## Proposal for a new supplement to the 00, 01, 02 and 03 series of amendments to UN Regulation No. 154

### Submitted by the expert from Australia.

The text reproduced below was prepared by the expert from Australia. This document proposes some inconsistency corrections to the 00, 01, 02 and 03 series of amendments to UNR154. The modifications to the current text of the Regulation are marked in bold for new or strikethrough for deleted characters.

### Annex A3

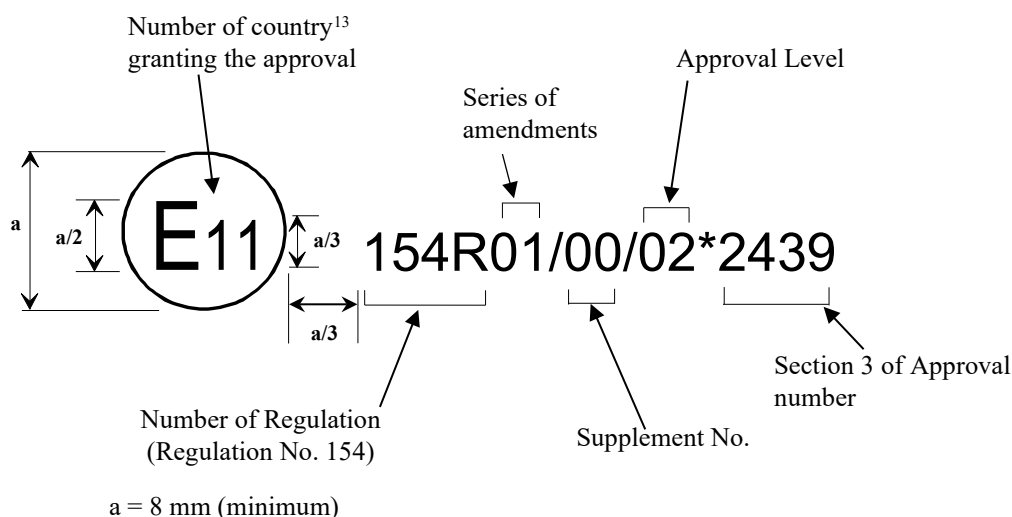
*Annex A3* – Amend to read:

1. The current format of the type approval mark illustrated in Annex A3 is not consistent with the requirements of Section 5.2.1, which may unintentionally lead to approval marks not being issued or accepted in the correct format. The proposed amendment to Annex A3 aligns the illustrated approval marks with the requirements of Section 5.2.1 and Schedule 4 of Revision 3 of the 1958 Agreement.
